Groundwater and Wastewater Services File Imaging Project

Groundwater & Wastewater Services
Septic Project File & Data Review Worksheet

SUBJECT: Revised septic system design on Lot 32 in Irongate Subdivision, Brief Road, Mecklenburg Co., NC.

IMPROVEMENT PERMIT for a RESIDENTIAL ON-SITE WASTEWATER TREATMENT & DISPOSAL SYSTEM

PROPOSED PLOT PLAN

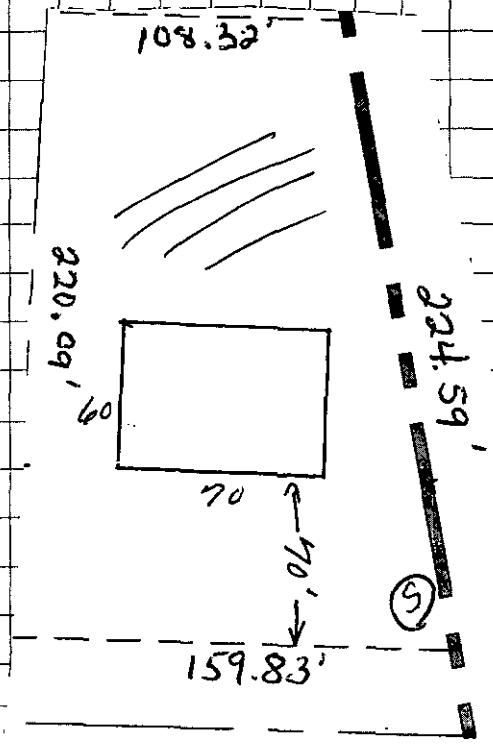
Lot 32 has an area that is **SUITABLE** for conventional or Innovative (EZflow) septic system. The soils are group 4 with mean depth to saprolite more than 40 inches and more than 42 inches to a seasonal water table. The septic system for a four bedroom house requires 400 linear feet of lines for the EZflow System. With an LTAR of 0.3 gpd/ft square, design flow of 480 GPD or 400 feet of lateral length of lines for an EZflow System required. The system should be in the middle part of the lot and have four lines at 100 feet for a total 400 liner feet. The trenches shall be 36 inches wide and not less than nine feet on center. The trench depths may vary between 20 and 28 inches. The repair area is down slope and can have the same EZflow system with five lines of 100, 100, 70, 70 and 70 feet for a total of 410 linear feet. (See attached lot map, design specifics, and soil/site evaluation.)

Design Review: TCT 8-3-07 ☒ ☐

Field Review: DLC 8/13/07 ☒

Sketch of Soil Evaluation Locations

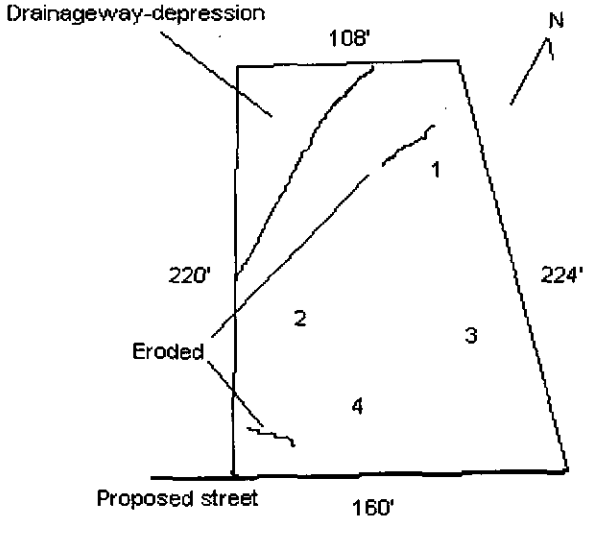
Based on the criteria set out in Title 15A, Subchapter 18A, of the North Carolina Administrative Code, Rules .1940 through .1948, the evaluation indicated that the site is **UNSUITABLE** for a ground absorption sewage system. Therefore, your request for an improvement permit is **DENIED.** A copy of the site evaluation is enclosed. The site is unsuitable based on the following:

- ☐ Unsuitable soil topography and/or landscape position (Rule .1940)
- ☐ Unsuitable soil characteristics (structure or clay mineralogy) (Rule .1941)
- ☐ Unsuitable soil wetness condition (Rule .1942)
- ☐ Unsuitable soil depth (Rule .1943)
- ☐ Presence of restrictive horizon (Rule .1944)
- ☒ Insufficient space for septic system and repair area (Rule .1945)
- ☒ Unsuitable for meeting required setbacks (Rule .1950)
- ☐ Other (Rule .1946)
